**SUBDIVISION,  
PLANNED UNIT DEVELOPMENT, &  
PLANNING APPROVAL  
STAFF REPORT****Date: May 18, 2017**

<b><u>APPLICANT NAME</u></b>	New Hope Baptist Church Subdivision, Resubdivision 2
<b><u>SUBDIVISION NAME</u></b>	New Hope Baptist Church Subdivision, Resubdivision 2
<b><u>DEVELOPMENT NAME</u></b>	New Hope Baptist Church Subdivision, Resubdivision 2
<b><u>LOCATION</u></b>	1270 & 1272 Pecan Street, 605 & 608 Live Oak Street, 1257, 1259, 1261 & 1263 Persimmon Street (Northeast corner of Pecan Street and Live Oak Street extending to the Southeast corner of Live Oak Street and Persimmon Street; and West side of Live Oak Street 120'± South of Persimmon Street).
<b><u>CITY COUNCIL DISTRICT</u></b>	District 2.
<b><u>PRESENT ZONING</u></b>	R-2, Two-Family Residential District.
<b><u>AREA OF PROPERTY</u></b>	1.39 ± acres.
<b><u>CONTEMPLATED USE</u></b>	Subdivision approval to create a single legal lot of record from a single legal lot of record and a single metes-and-bounds parcel; Planned Unit Development to amend a previously approved Planned Unit Development to allow off-site parking; and Planning Approval to amend a previous Planning Approval to allow the expansion of a church and co

# SITE PLAN

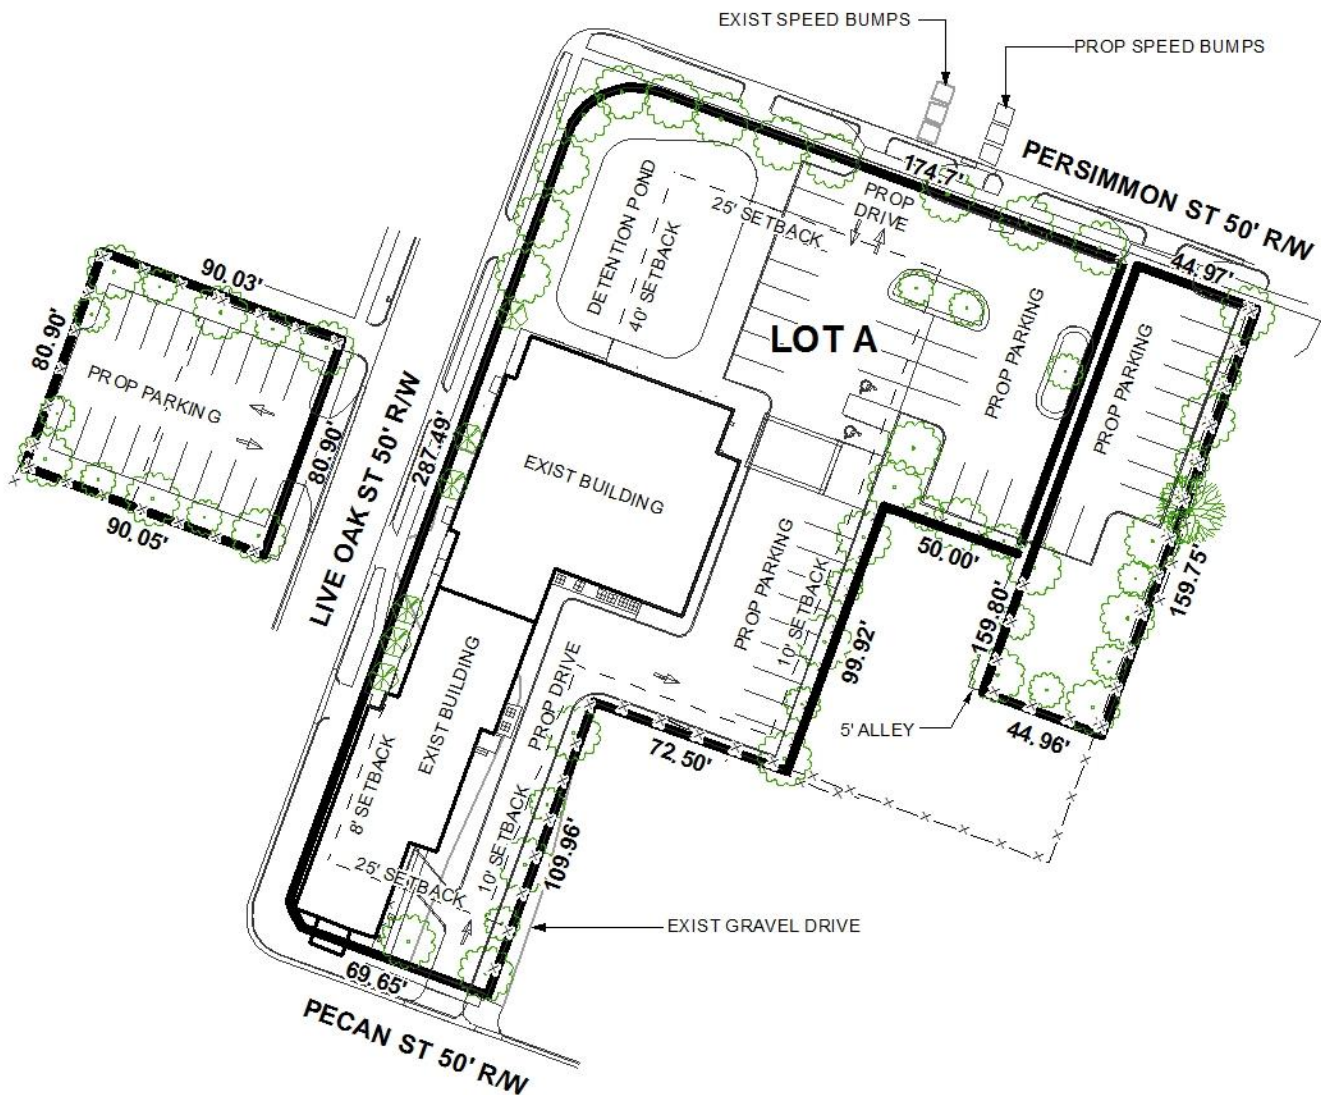
The proposed site plan illustrates a new detention pond area at the Northwest of the property. Due to the addition of the detention pond, the church is proposing to utilize the two properties to the East of the church to provide the amount of required parking which was previously located where the detention pond is now illustrated. The church will have 246 seats, making 62 parking

spaces required. The site plan illustrates 63 parking spaces will be provided, including the off-site lot.

Any new lighting on the site will have to comply with the requirements of Sections 64-4.A.2., 64-6.A.3.c., and 64-6.A.8. of the Zoning Ordinance. A note reflecting this requirement should appear on the site plan, and photometric plans will be required at the time of permitting.

The site plan does not illustrate a dumpster on the property, however, there is a note stating that garbage collection will be via curb-side pick-up, which should be retained on the site plan, if approved.

The site plan indicates that there will be sufficient landscaped area on both the main campus for the church as well as the off-site parking. As noted previously, the site has a variance on the June 5, 2017 meeting to address a proposed shortage of tree plantings along Live Oak Street due to the close proximity of the church building to the street.

A wooden privacy fence is depicted where the site is adjacent to R-2, Two-Family Residential District properties occupied by single family dwelling units, with the fence to be 6' and reduced to 3' with the front building setbacks. This should be retained on the site plan, if approved.

- 1) removal of the 5' alley and/or provision of legal documentation regarding the alley;
- 2) retention of the note regarding the use of curb-side pickup;

- 3) retention of the 6' high wooden privacy fence where the sites abut single family dwellings;
- 4) placement of a note on the site plan stating the site will comply with the requirements of Sections 64-4.A.2., 64-6.A.3.c., and 64-6.A.8. of the Zoning Ordinance;

- 5) placement of a note on the site plan stating the site is limited to one curb cut to Pecan Street, and two curb cuts to Persimmon Street, with changes in the size, location and design to be approved by Traffic Engineering and conform to AASHTO standards; and any unused existing curb cuts should be removed and replaced with landscaping and curb;
